Comments and Response Report

The Proposed Housing Development on Portions 91 of the Farm Matjes Fontein 304, Plettenberg Bay, Western Cape.

DEA&DP Ref. No: 16/3/3/1/D1/13/0001/25

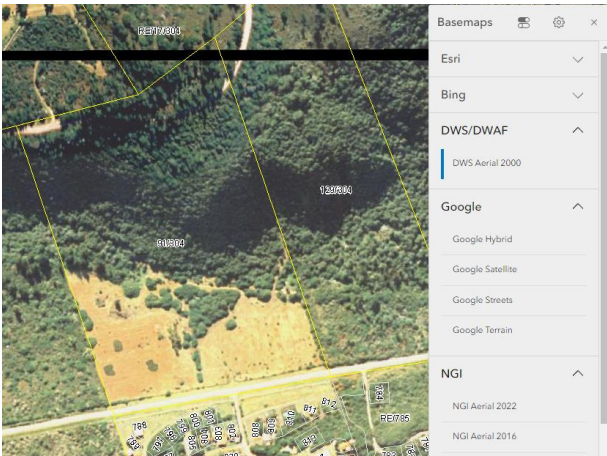
to rehabilitate and rewild the degraded area. From the photograph below it is very obvious that this particular land has been purposefully degraded and given ten years would easily rehabilitate all the indigenous flora that grows in the area.

Figure 60

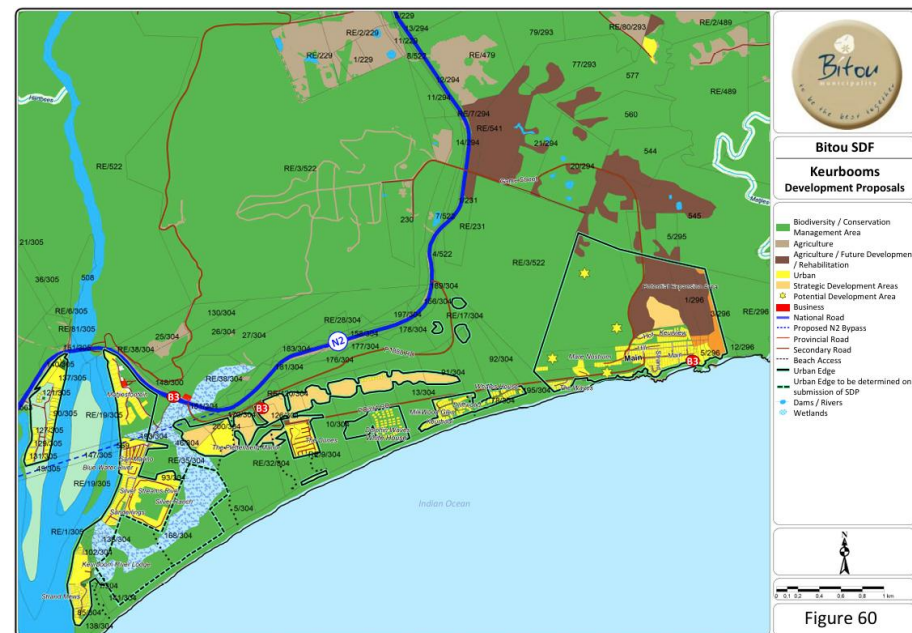
It should be taken into consideration that a portion south of the site is earmarked as a "Strategic Development Area" within the urban edge (Figure 60 of the Bitou SDF 2022).

The Plant, Animal & Terrestrial Biodiversity Assessment by Dr. David Hoare has been updated and includes the preferred layout of 60 housing units with an

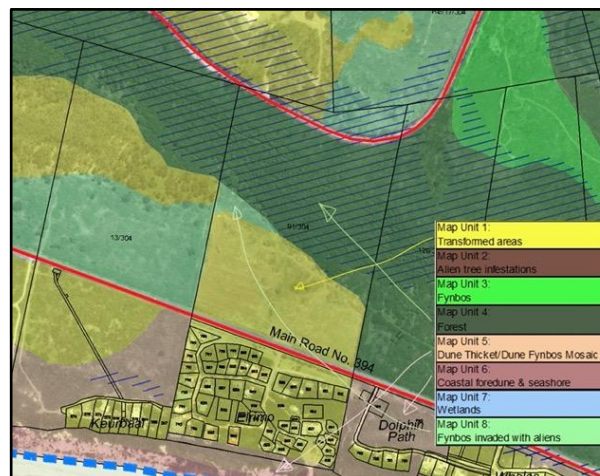
In the consideration of alternatives, the principles of sustainable development should be practicable, feasible, reasonable, and viable.

The preferred Alternative offers a lower density to Alternative 1, and further consideration to environmental sensitivities by including buffers from these areas. The Preferred Alternative was guided by consultation with specialists to find a balance between environmental and financial sustainability. The outcome of consultation with specialists is that the layout of 60 units offers the best practical option that considers sustainable development that is viable, and reasonable within the context of environmental conservation.

Alternative 2 was considered as it aligns with the KELASP of 19 units, which takes the 4.5m contour line into account within the identified transformed area. The parameter restricting development below 4,5m contour line was investigated by the freshwater specialist, and was determined to play no role in the functionality of the wetland and is not within an EFZ. Ground truthing by specialists indicated that there is no sound reason why the area below 4,5m contour line should be excluded from the development, as long as all mitigation measures are adhered to. Given this determination, the 6ha of transformed area, as per the KELASP, could be considered for development within the parameter for the development node, as follows - *The Spatial Plan has identified development nodes for this area. For these nodes, a gross density profile of 12 units per ha of the identified transformed footprint area is proposed. The latter is based on the guideline of 15 units per hectare proposed for smaller rural settlements as contained in the Draft Bitou SDF (2013).*

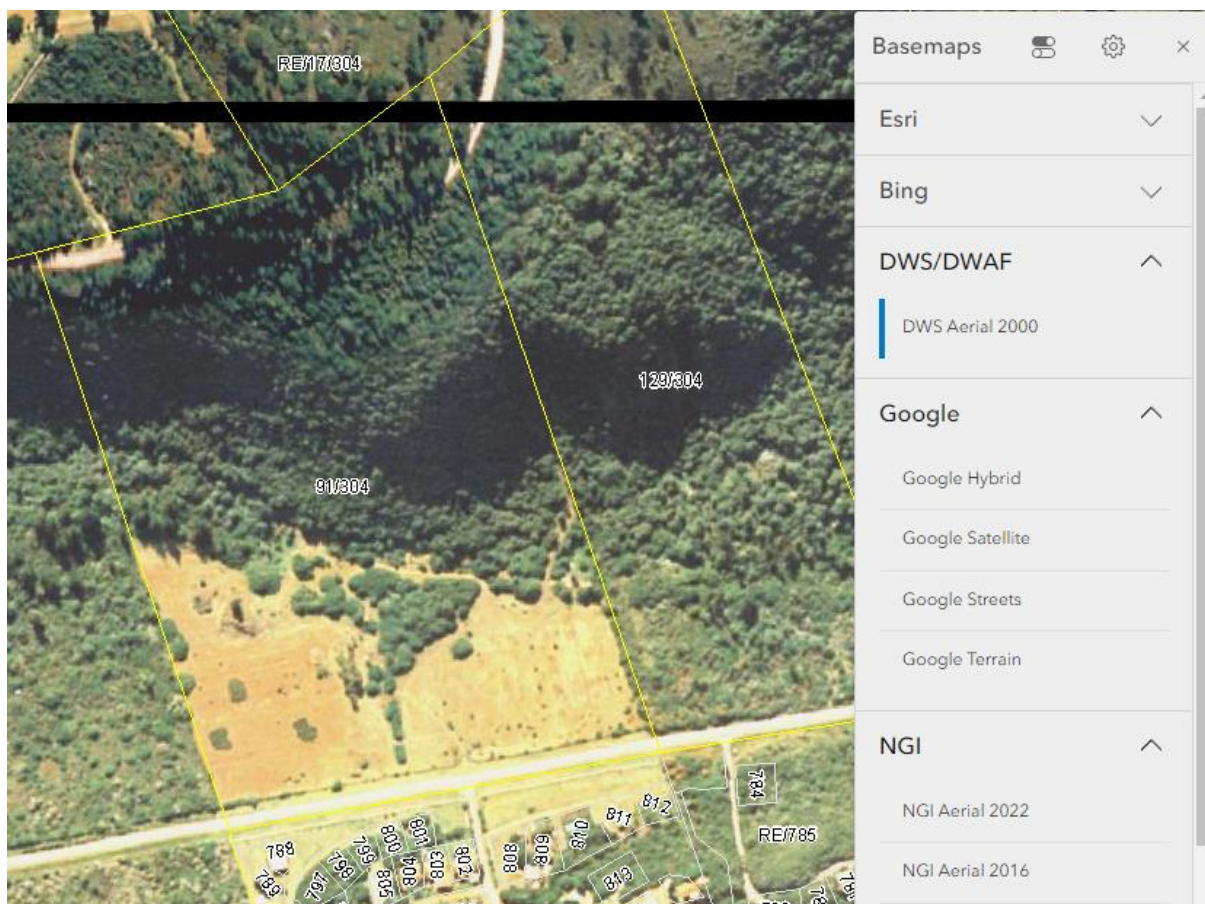
The urban edge in this area has been defined by the steep sloped to the north and the 5m contour line which defines the Estuarine Functional Zone to the south.

The reason why the proposed development area extends beyond the identified urban edge is because the Aquatic Assessment confirmed that the area contains no estuarine habitats and is outside of the 1:100-year flood line of the estuary and is thus not part of the estuarine functional zone and for this reason the 4,5 or 5m contour line has not been observed. The steep slopes and forest vegetation to the north has however been identified as sensitive and have been protected with a 20m buffer strip.

2002 DWS image indicting that the property is being cultivated

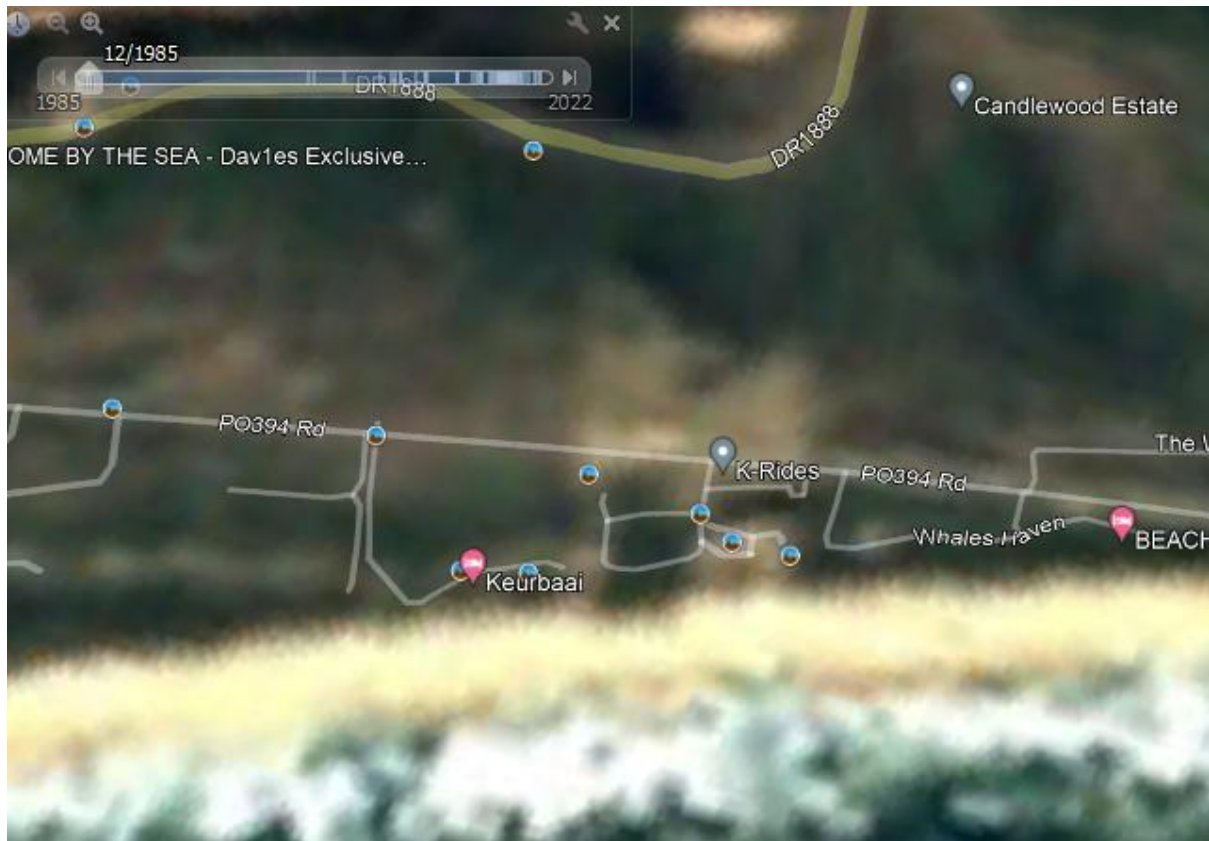
The allegations are there for completely untrue.

1985 historical google image indicated that the portion is being farmed.
